## MONTGOMERY COUNTY HISTORIC PRESERVATION COMMISSION STAFF REPORT

Address: 2 High St., Brookeville Meeting Date: 5/24/2017

Case Number: 23/65-17C RETROACTIVE Staff: Michael Kyne

**PROPOSAL:** Front porch alterations, window replacement, and other alterations

Existing & Proposed

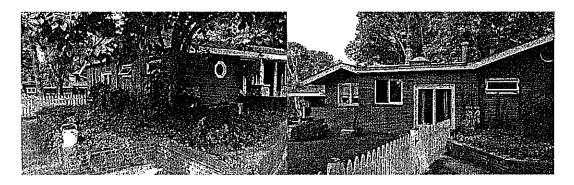
The applicant proposes to restore the original front porch, using available information from the Aladdin catalog and extant physical evidence. Two columns on tapered stone piers to match the existing will be added at the front/left side of the porch, and a wooden railing will be reconstructed to match a small section of the original railing that remains at the right side of the porch (see Circle 18). The restored front porch will largely match that shown in the Aladdin catalog, although a non-historic sunroom addition at the left side of the historic house will remain. Any wood flooring or steps that need to be replaced will be replaced in-kind.

A non-compatible single-lite window on the left elevation of the historic house is proposed to be replaced with a double-hung 6-over-1 window, which will match the original windows in style and material (see Circle 18).

## Sun Room Alteration

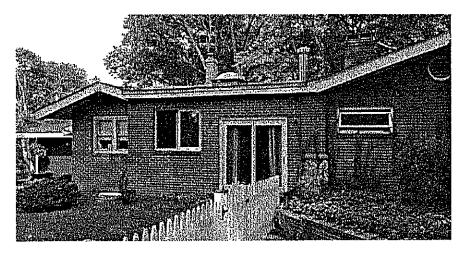
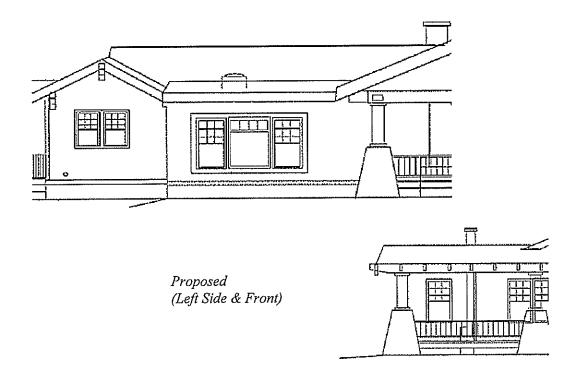
Currently, the non-historic sun room addition at the left side of the historic house is covered with brick, which was continued from the non-historic enclosure/addition that is proposed to be removed from the front of the house. The applicant proposes to remove the brick from the sunroom and install cedar shakes in its place. A historically incompatible sliding glass window and door will be removed from the left side of the sunroom, and a new ganged window will be installed in their place (there are similar ganged windows at the front and on the right side of the historic house). A double-hung 9-over-1 window will be installed on the front of the sunroom. The proposed windows will be consistent with the windows on the historic house in style and material.

## Deck Replacement

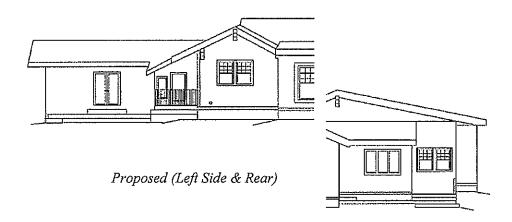
A small wooden deck will be removed from the rear/left side (as viewed from the front) of the house, and a new wooden deck of the same approximate dimensions will be installed in its place. The existing deck does not have a railing, but, for code compliance, a railing is proposed along the left side of the proposed new deck. The proposed deck is relatively small, at the rear of the property, and largely obscured by the existing sun room at the left side of the house.

1. Deck railing details will be submitted, with final review and approval delegated to staff.
